ADDENDUM No. 2
Solicitation 26-99071
Palm Street Smart Pond

ADDENDUM #2, January 23, 2026
Palm Street Smart Pond
City Project # 2208

PALM STREET PERMANENT STORMWATER MANAGEMENT SYSTEM IMPROVEMENTS

SS-199 DRAINAGE STRUCTURE DESIGN SPECIAL 2 - FLOW CONTROL GATE

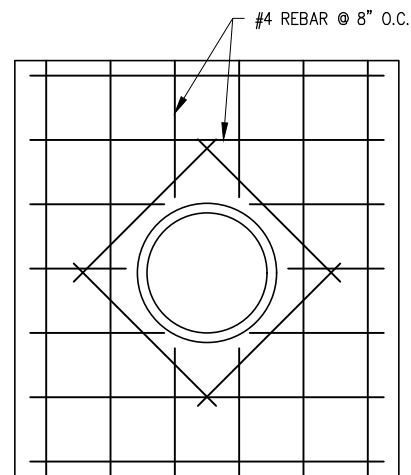
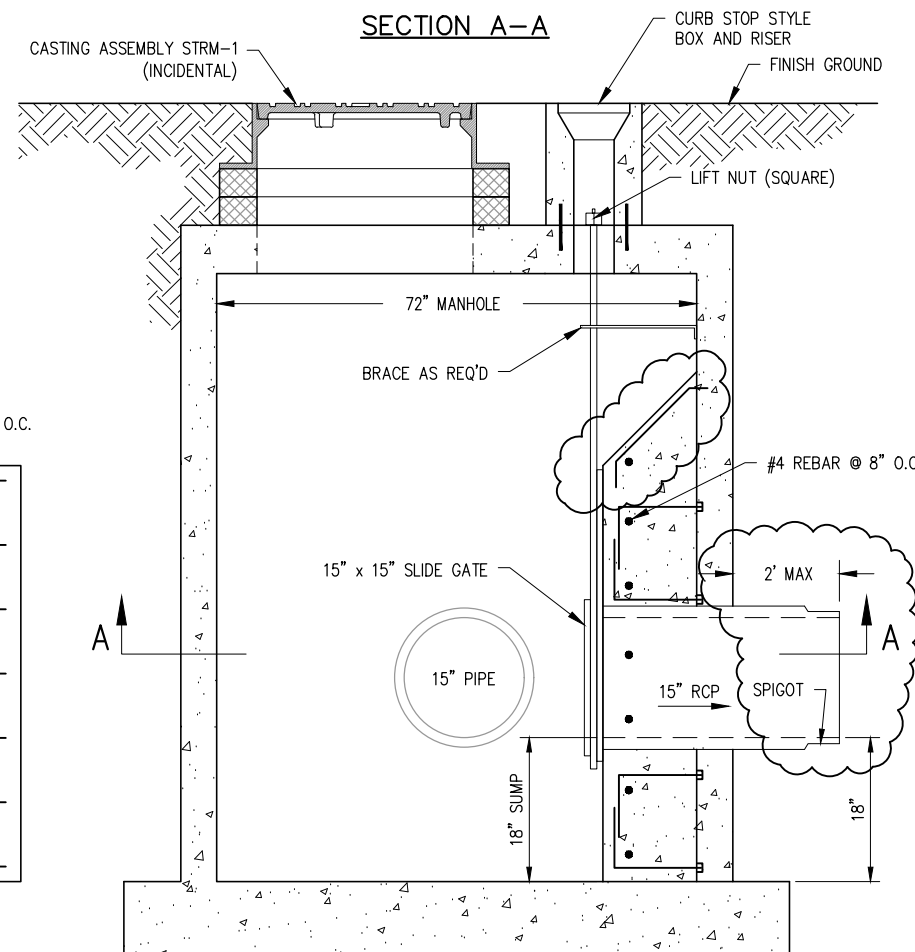
7. Drawing changes to the SMART POND CONTROLS are as follows:
 - a. Sheet SC01; Delete Sheet SC01 in its entirety and replace with revised Sheet SC01.
 - b. Sheet SC02; Delete Sheet SC02 in its entirety and replace with revised Sheet SC02.
 - c. Sheet SC03; Delete Sheet SC03 in its entirety and replace with revised Sheet SC03.
 - d. Sheet SC04; Delete Sheet SC04 in its entirety and replace with revised Sheet SC04.

- 1. TOP SLAB THICKNESS AND REINFORCEMENT SHALL CONFORM TO MNDOT STANDARD PLATE 4020J.
- 2. ENTRY ACCESS HOLE SHALL BE ECCENTRIC OPPOSITE LOCATION OF SLIDE GATE.

SMART POND CONTROLS
SHEET NO. SC02R OF SC04 SHEETS

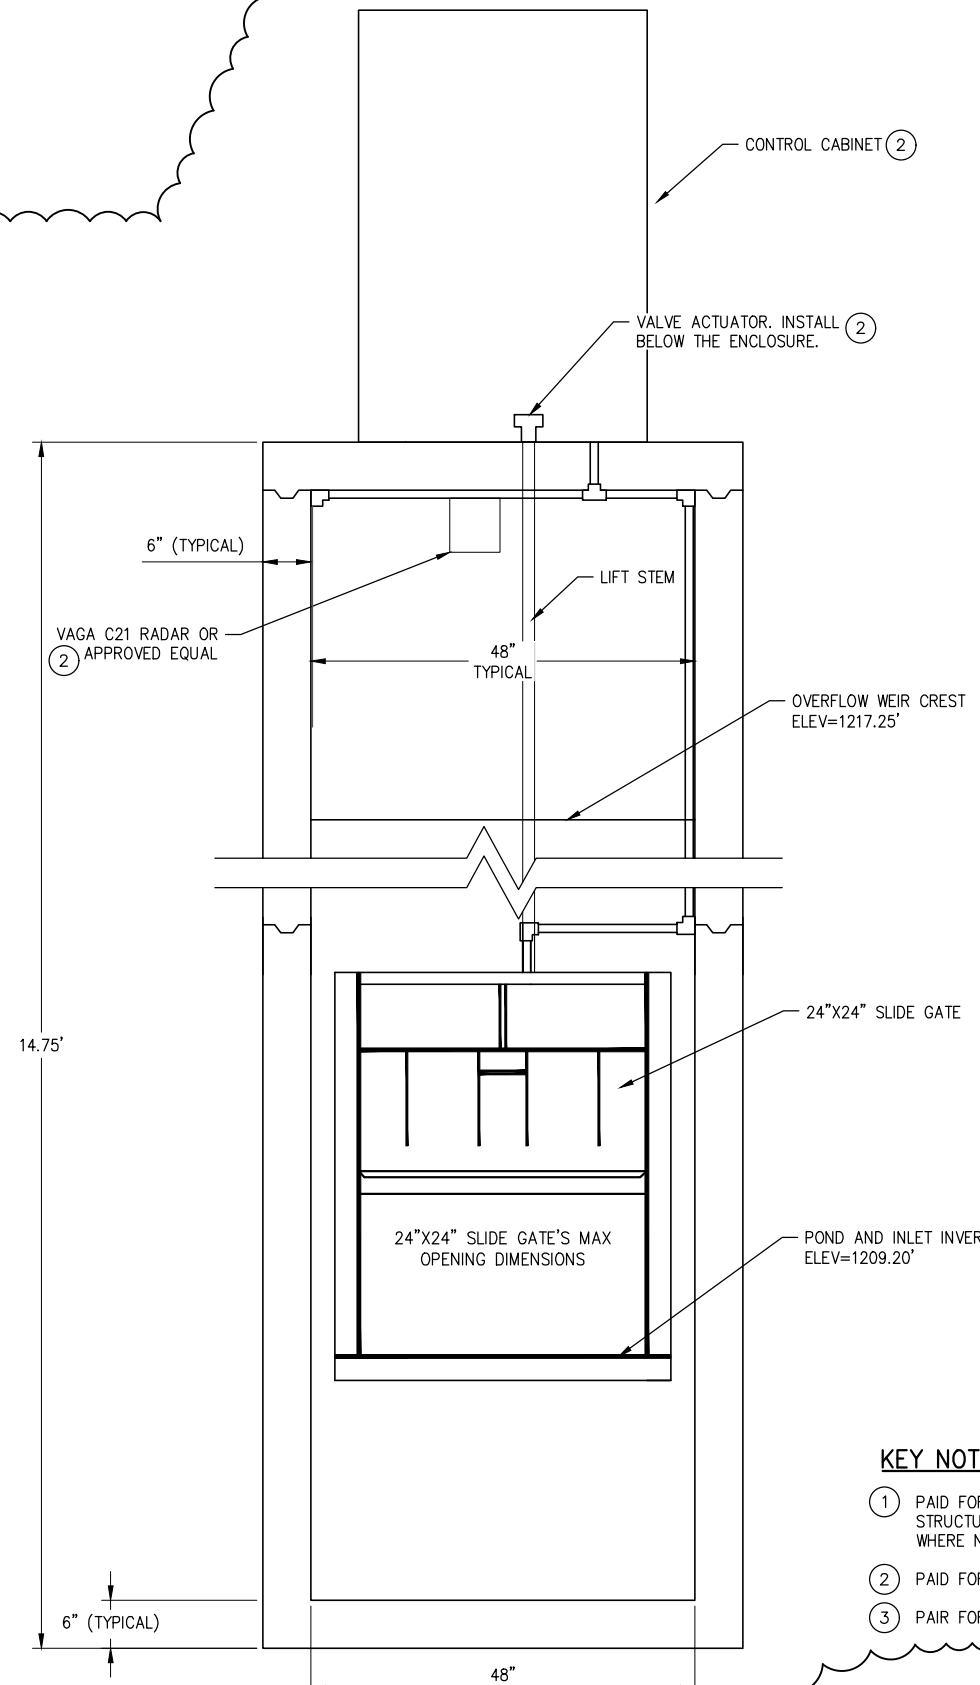
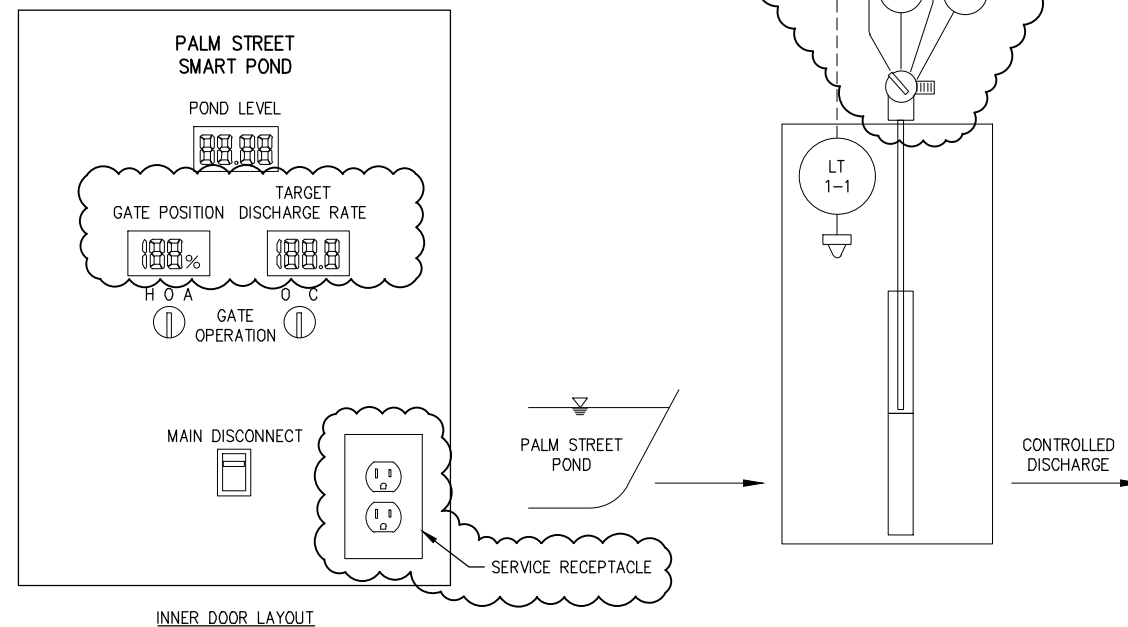
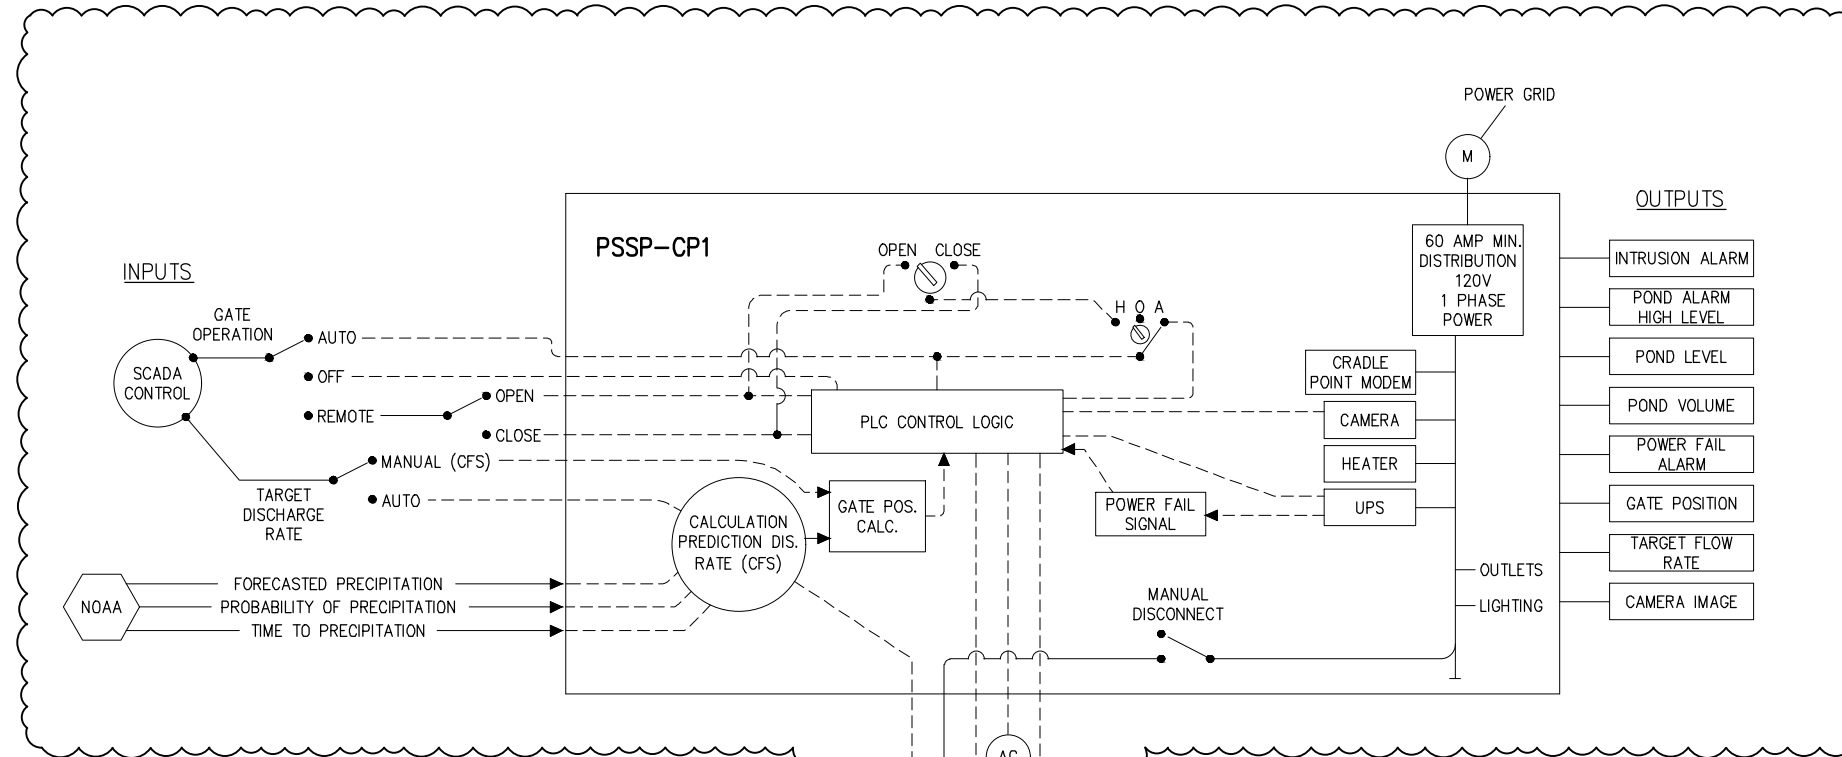
4. **Question:** Can location of existing sanitary pipe be confirmed using televising rather than potholing?
Answer: Yes.
5. **Question:** In spec section SP-35 the size of the control gate is called out as 24"X24" and on plan sheet SC-02 its calling for a 36"X36" slide gate. Which size gate should we include in our pricing because it was our understanding the 24" diam outlet pipe controls and that a 24"X24" gate is adequate for this application?

Answer: This was a plan inaccuracy; the addendum will address this.
6. **Question:** Does the City have a preference on whether the gate is actuated or uses a threaded stem screw gate?
